Upwell

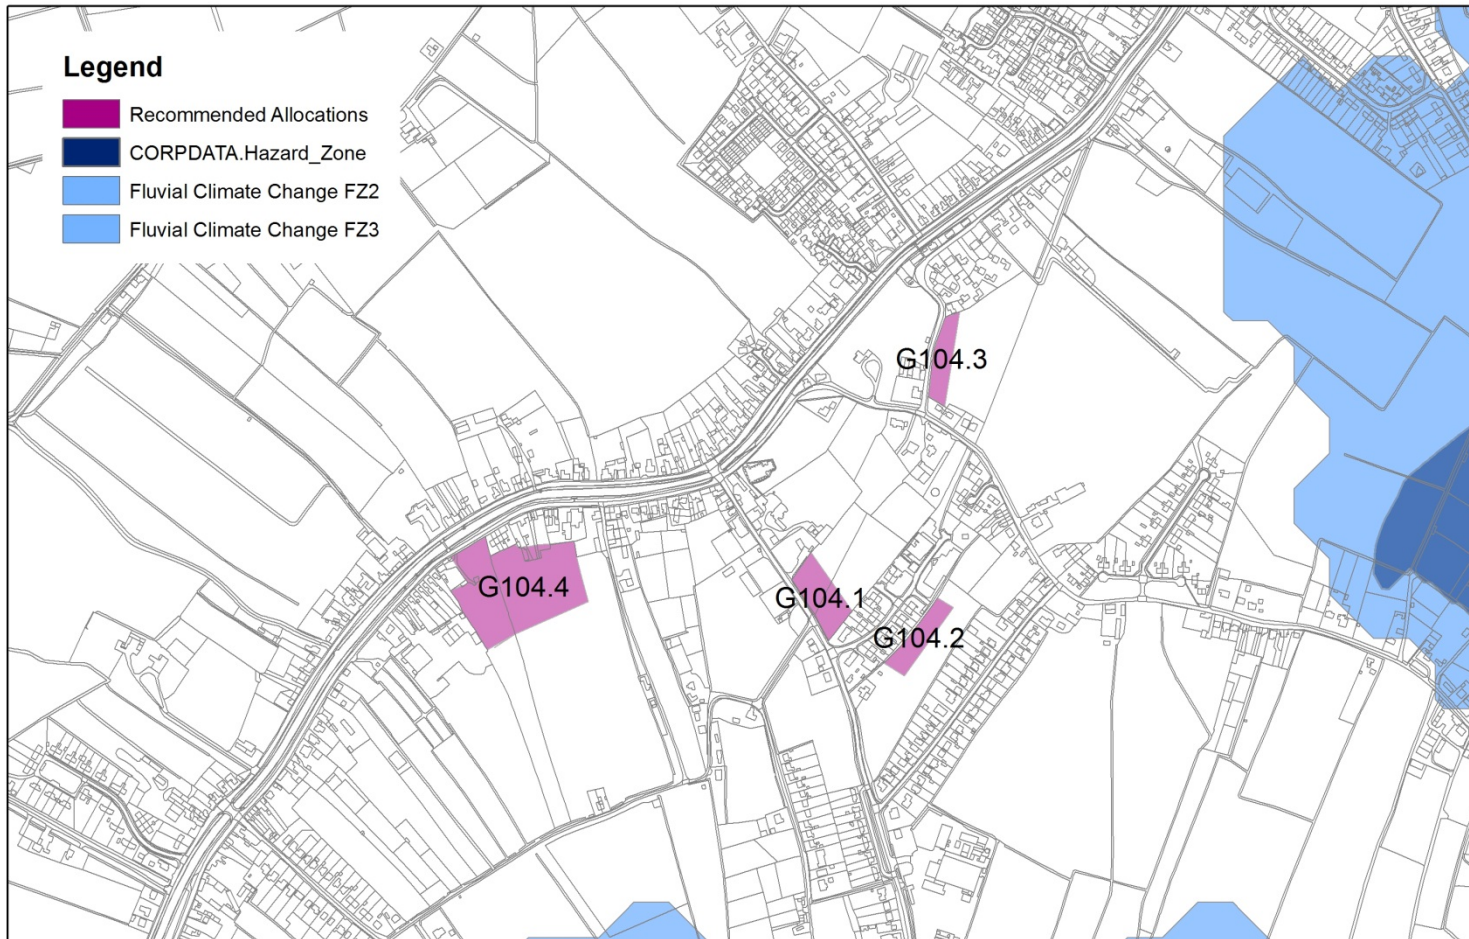
Flood Risk	Statutory consultee comments	Flood Risk - Noted in the Sustainability Appraisal	Council's Approach in the proposed SADMP policy	Agents / Land owner response
<p>Flood Zone 1</p>	<p>Miss Emily Crook (ID: 476133), The Environment Agency:</p> <ul style="list-style-type: none"> We have reviewed the draft allocations set out within Section G and have no objection. We consider that flood risk to these sites can be adequately addressed at full planning stage by the application of draft policy DM21 (Sites in Areas of Flood Risk). <p>Graham Moore (ID: 138584) , Middle Level Commissioners:</p> <ul style="list-style-type: none"> Consider that fifteen dwellings meeting current standards and the Board's requirements without increasing flood risk may be non-technically viable or deliverable at this location. 	<p>'+' Despite sites being located within Flood Zone 1 (low risk) there were concerns raised regarding the drainage and flood risk. The Environment Agency submitted further information regarding the level and scale of flood risk within both settlements and supported the overall approach taken by the Council with regards to the sequential assessment of sites.</p>	<ul style="list-style-type: none"> Allocation is proposed for a reduction in dwelling numbers from 15 to 5 in order to reflect the local settlement pattern. The detail of the scheme can be developed in consultation with Norfolk County Council, as the Lead Local Flood Authority, and the Middle Level Commissioners at the design process stage that would inform a detailed planning application Having liaised with Development Control regarding the Middle Level Commissioners comments they are confident there is a design solution. This has been and is current practice with planning applications within this locality 	<ul style="list-style-type: none"> Agent states (Appendix 2) that in their experience soakaways work perfectly well in this area, and that percolation tests will be carried out to determine type and size.

Flood Risk	Statutory consultee comments	Flood Risk - Noted in the Sustainability Appraisal	Council's Approach in the proposed SADMP policy	Agents / Land owner response
Flood Zone 1	<p>Miss Emily Crook (ID: 476133), The Environment Agency:</p> <ul style="list-style-type: none"> We have reviewed the draft allocations set out within Section G and have no objection. We consider that flood risk to these sites can be adequately addressed at full planning stage by the application of draft policy DM21 (Sites in Areas of Flood Risk). <p>Graham Moore (ID: 138584) , Middle Level Commissioners:</p> <ul style="list-style-type: none"> Consider that five dwellings meeting current standards and the Board's requirements without increasing flood risk may be non-technically viable or deliverable at this location. 	<p>'+' Despite sites being located within Flood Zone 1 (low risk) there were concerns raised regarding the drainage and flood risk. The Environment Agency submitted further information regarding the level and scale of flood risk within both settlements and supported the overall approach taken by the Council with regards to the sequential assessment of sites.</p>	<ul style="list-style-type: none"> The detail of the scheme can be developed in consultation with Norfolk County Council, as the Lead Local Flood Authority, and the Middle Level Commissioners at the design process stage that would inform a detailed planning application Having liaised with Development Control regarding the Middle Level Commissioners comments they are confident there is a design solution. This has been and is current practice with planning applications within this locality 	<ul style="list-style-type: none"> Land owner response (Appendix 3).

Flood Risk	Statutory consultee comments	Flood Risk - Noted in the Sustainability Appraisal	Council's Approach in the proposed SADMP policy	Agents / Land owner response
Flood Zone 1	<p>Miss Emily Crook (ID: 476133), The Environment Agency:</p> <ul style="list-style-type: none"> We have reviewed the draft allocations set out within Section G and have no objection. We consider that flood risk to these sites can be adequately addressed at full planning stage by the application of draft policy DM21 (Sites in Areas of Flood Risk). <p>Graham Moore (ID: 138584) , Middle Level Commissioners:</p> <ul style="list-style-type: none"> Consider that five dwellings meeting current standards and the Board's requirements without increasing flood risk may be non-technically viable or deliverable at this location. 	<p>'+' Despite sites being located within Flood Zone 1 (low risk) there were concerns raised regarding the drainage and flood risk. The Environment Agency submitted further information regarding the level and scale of flood risk within both settlements and supported the overall approach taken by the Council with regards to the sequential assessment of sites.</p>	<ul style="list-style-type: none"> The detail of the scheme can be developed in consultation with Norfolk County Council, as the Lead Local Flood Authority, and the Middle Level Commissioners at the design process stage that would inform a detailed planning application Having liaised with Development Control regarding the Middle Level Commissioners comments they are confident there is a design solution. This has been and is current practice with planning applications within this locality 	<ul style="list-style-type: none"> Land owner response (Appendix 4).

Flood Risk	Statutory consultee comments	Flood Risk - Noted in the Sustainability Appraisal	Council’s Approach in the proposed SADMP policy	Agents / Land owner response
Flood Zone 1	<p>Miss Emily Crook (ID: 476133), The Environment Agency:</p> <ul style="list-style-type: none"> We have reviewed the draft allocations set out within Section G and have no objection. We consider that flood risk to these sites can be adequately addressed at full planning stage by the application of draft policy DM21 (Sites in Areas of Flood Risk). <p>Graham Moore (ID: 138584) , Middle Level Commissioners:</p> <ul style="list-style-type: none"> Consider that fifteen dwellings meeting current standards and the Board’s requirements without increasing flood risk may be non-technically viable or deliverable at this location. 	<p>‘+’ Despite sites being located within Flood Zone 1 (low risk) there were concerns raised regarding the drainage and flood risk. The Environment Agency submitted further information regarding the level and scale of flood risk within both settlements and supported the overall approach taken by the Council with regards to the sequential assessment of sites.</p>	<ul style="list-style-type: none"> Provision of a drainage strategy to address surface water run-off and requirements set down by the statutory consultees to reduce flood risk. The detail of the scheme can be developed in consultation with Norfolk County Council, as the Lead Local Flood Authority, and the Middle Level Commissioners at the design process stage that would inform a detailed planning application Having liaised with Development Control regarding the Middle Level Commissioners comments they are confident there is a design solution. This has been and is current practice with planning applications within this locality 	<ul style="list-style-type: none"> Detailed response from Agent (Appendix 2) states that the development is possible.

Outwell

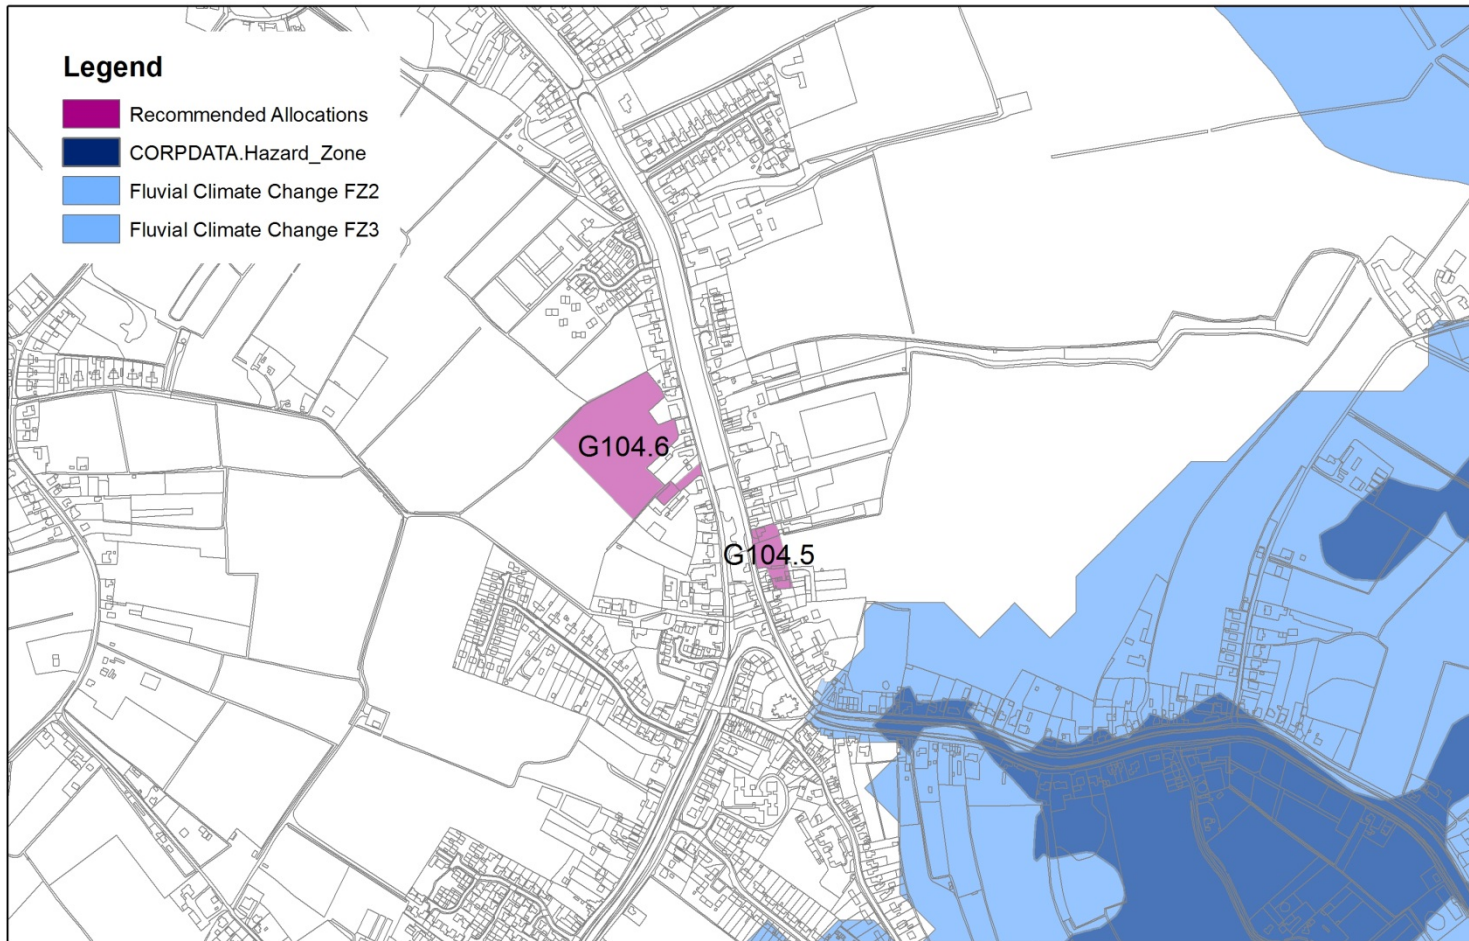
Flood Risk	Statutory consultee comments	Flood Risk - Noted in the Sustainability Appraisal	Council’s Approach in the proposed SADMP policy	Agents / Land owner response
Flood Zone 1	<p>Miss Emily Crook (ID: 476133), The Environment Agency:</p> <ul style="list-style-type: none"> We have reviewed the draft allocations set out within Section G and have no objection. We consider that flood risk to these sites can be adequately addressed at full planning stage by the application of draft policy DM21 (Sites in Areas of Flood Risk). <p>Graham Moore (ID: 138584) , Middle Level Commissioners:</p> <ul style="list-style-type: none"> Consider this site and the number of dwellings proposed constrained from water level/flood risk management perspective, It is considered that 35 dwellings meeting current standards and the Board's requirements without increasing flood risk may be non-technically viable or deliverable at this location. 	<p>‘+’ Despite sites being located within Flood Zone 1 (low risk) there were concerns raised regarding the drainage and flood risk. The Environment Agency submitted further information regarding the level and scale of flood risk within both settlements and supported the overall approach taken by the Council with regards to the sequential assessment of sites.</p>	<ul style="list-style-type: none"> The detail of the scheme can be developed in consultation with Norfolk County Council, as the Lead Local Flood Authority, and the Middle Level Commissioners at the design process stage that would inform a detailed planning application Having liaised with Development Control regarding the Middle Level Commissioners comments they are confident there is a design solution. This has been and is current practice with planning applications within this locality 	<ul style="list-style-type: none"> Response from Agent (Appendix 5) states that the development is possible.

G106.1

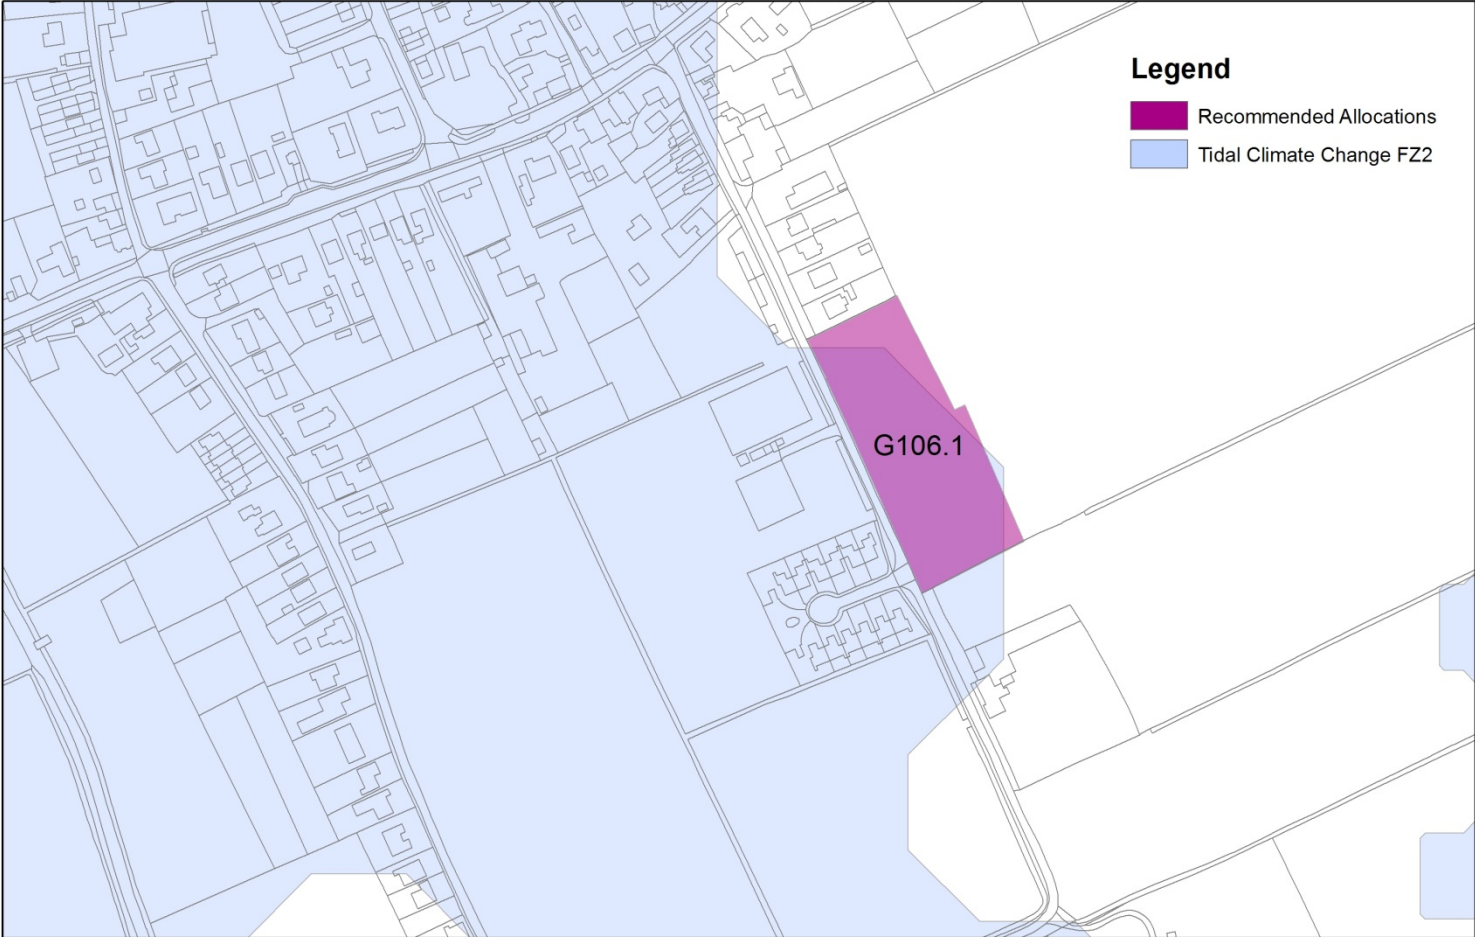
Flood Risk	Statutory consultee comments	Flood Risk - Noted in the Sustainability Appraisal	Council's Approach in the proposed SADMP policy
<p>Flood Zone 2</p>	<p>Miss Emily Crook (ID: 476133), The Environment Agency:</p> <ul style="list-style-type: none"> We have reviewed the draft allocations set out within Section G and have no objection. We consider that flood risk to these sites can be adequately addressed at full planning stage by the application of draft policy DM21 (Sites in Areas of Flood Risk). 	<p>'+/' a large portion of the site is constrained by medium flood risk (flood zone 2).</p>	<ul style="list-style-type: none"> Submission of a Flood Risk Assessment (FRA) that should address all forms of flood risk (coastal inundation, fluvial, pluvial and groundwater). The FRA should explain how surface water drainage will be managed. The FRA must demonstrate how the development would provide wider sustainability benefits to the community that outweigh the risk associated with flooding and that the development would be safe for its lifetime without increasing flood risk elsewhere and, where possible, would reduce flood risk overall. The FRA should also suggest appropriate mitigation (flood resiliency measures) Submission of details showing how sustainable drainage measures will be incorporated into the development to avoid discharge to the public surface water network, and also to the amenity and biodiversity of the development. A suitable plan for the future management and maintenance of the Sustainable Drainage System (SUDS) should be included with the submission

Welney

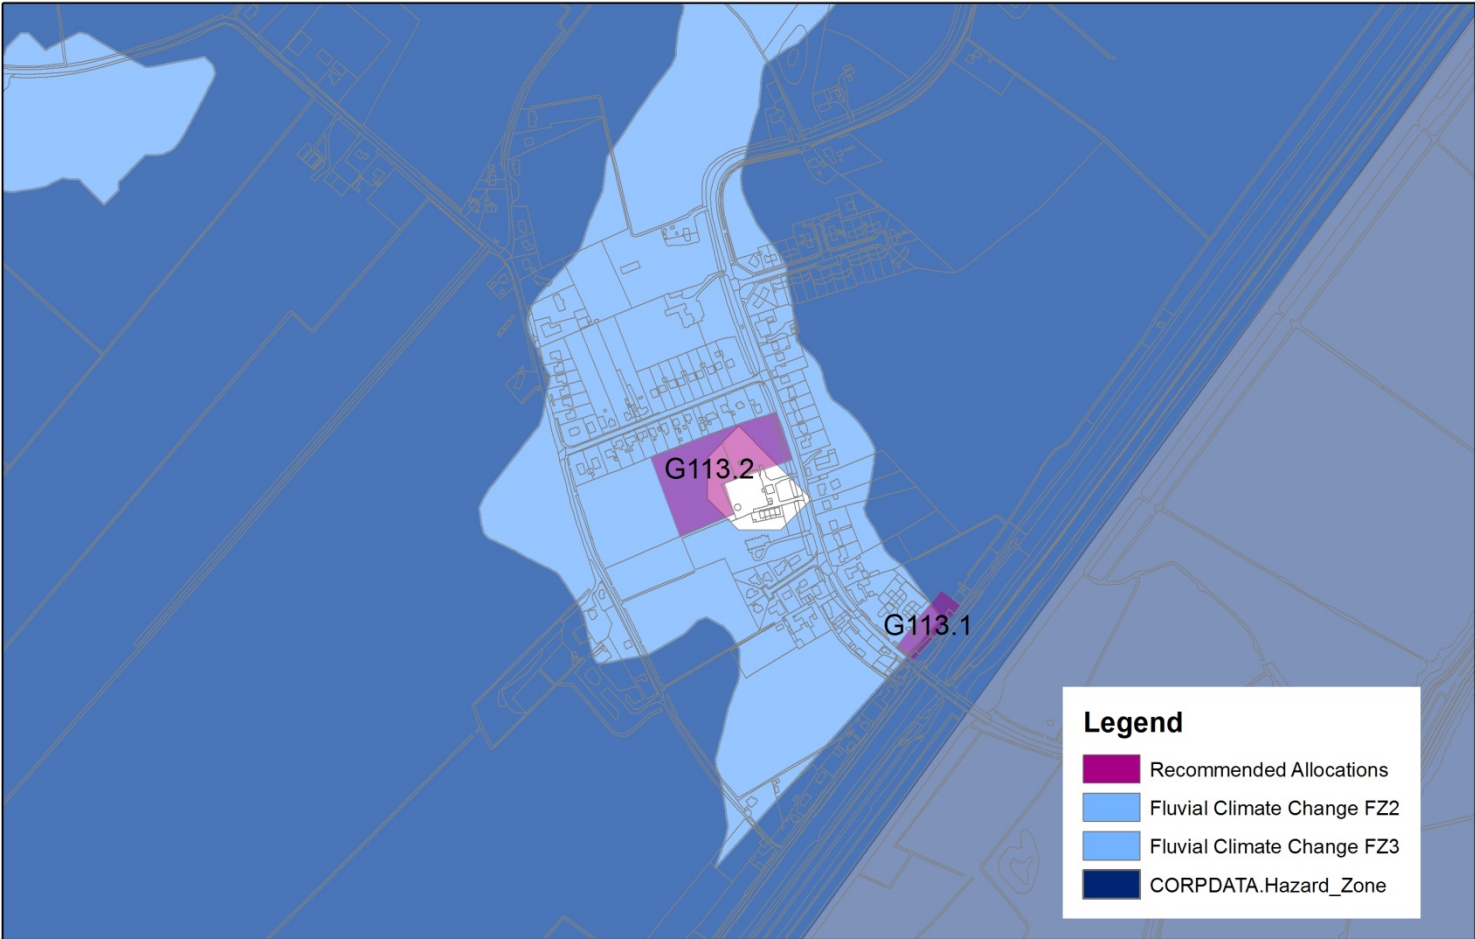
Flood Risk	Statutory consultee comments	Flood Risk - Noted in the Sustainability Appraisal	Council's Approach in the proposed SADMP policy	Agents / Land owner response
<p>Flood Zone 3 & Partial Hazard Zone</p>	<p>Miss Emily Crook (ID: 476133), The Environment Agency:</p> <ul style="list-style-type: none"> We have reviewed the draft allocations set out within Section G and have no objection. We consider that flood risk to these sites can be adequately addressed at full planning stage by the application of draft policy DM21 (Sites in Areas of Flood Risk). <p>Graham Moore (ID: 138584) , Middle Level Commissioners:</p> <ul style="list-style-type: none"> Consider that 7 dwellings meeting current standards and the Board's requirements without increasing flood risk may be non-technically viable or deliverable at this location. 	<p>'xx' The site is in flood zone 3 and a hazard zone flooding.</p> <p>All sites perform poorly in terms of flood risk.</p> <p>Potential negative impacts arising from drainage constraints could be addressed by good design.</p> <p>Middle Level Commissioners have expressed concerns relating to surface water drainage, the capacity of the receiving networks and ground conditions.</p>	<ul style="list-style-type: none"> Submission of a Flood Risk Assessment (FRA) that should address all forms of flood risk (coastal inundation, fluvial, pluvial and groundwater). The FRA should explain how surface water drainage will be managed. The FRA must demonstrate how the development would provide wider sustainability benefits to the community that outweigh the risk associated with flooding and that the development would be safe for its lifetime without increasing flood risk elsewhere and, where possible, would reduce flood risk overall. The FRA should also suggest appropriate mitigation (flood resiliency measures) The detail of the scheme can be developed in consultation with Norfolk County Council, as the Lead Local Flood Authority, and the Middle Level Commissioners at the design process stage that would 	<ul style="list-style-type: none"> Response from Agent (Appendix 5) states that the development is possible.

Flood Risk	Statutory consultee comments	Flood Risk - Noted in the Sustainability Appraisal	Council's Approach in the proposed SADMP policy	Agents / Land owner response
Partial Flood Zone 3	<p>Miss Emily Crook (ID: 476133), The Environment Agency:</p> <ul style="list-style-type: none"> We have reviewed the draft allocations set out within Section G and have no objection. We consider 	<p>'xx' Parts of the site are subject to high flood risk (FZ3) including the site access.</p> <p>Development is subject</p>	<ul style="list-style-type: none"> Submission of a Flood Risk Assessment (FRA) that should address all forms of flood risk (coastal inundation, fluvial, pluvial and groundwater). The FRA should explain how 	<ul style="list-style-type: none"> Response from Agent (Appendix 5) states that the development is possible.

Flood Risk	Statutory consultee comments	Flood Risk - Noted in the Sustainability Appraisal	Council's Approach in the proposed SADMP policy	Agents / Land owner response
			<p>inform a detailed planning application</p> <ul style="list-style-type: none"> Having liaised with Development Control regarding the Middle Level Commissioners comments they are confident there is a design solution. This has been and is current practice with planning applications within this locality

Flood Risk	Statutory consultee comments	Flood Risk - Noted in the Sustainability Appraisal	Council's Approach in the proposed SADMP policy	Agents / Land owner response
	<p>that flood risk to these sites can be adequately addressed at full planning stage by the application of draft policy DM21 (Sites in Areas of Flood Risk).</p> <p>Graham Moore (ID: 138584) , Middle Level Commissioners:</p> <ul style="list-style-type: none"> Consider that 13 dwellings meeting current standards and the Board's requirements without increasing flood risk may be non-technically viable or deliverable at this location. 	<p>to the appropriate flood mitigation measures.</p> <p>Potential negative impacts arising from drainage constraints could be addressed by good design.</p> <p>Middle Level Commissioners have expressed concerns relating to surface water drainage, the capacity of the receiving networks and ground conditions.</p>	<p>surface water drainage will be managed. The FRA must demonstrate how the development would provide wider sustainability benefits to the community that outweigh the risk associated with flooding and that the development would be safe for its lifetime without increasing flood risk elsewhere and, where possible, would reduce flood risk overall. The FRA should also suggest appropriate mitigation (flood resiliency measures)</p> <ul style="list-style-type: none"> The detail of the scheme can be developed in consultation with Norfolk County Council, as the Lead Local Flood Authority, and the Middle Level Commissioners at the design process stage that would inform a detailed planning application Having liaised with Development Control regarding the Middle Level

Flood Risk	Statutory consultee comments	Flood Risk - Noted in the Sustainability Appraisal	Council's Approach in the proposed SADMP policy	Agents / Land owner response
			Commissioners comments they are confident there is a design solution. This has been and is current practice with planning applications within this locality
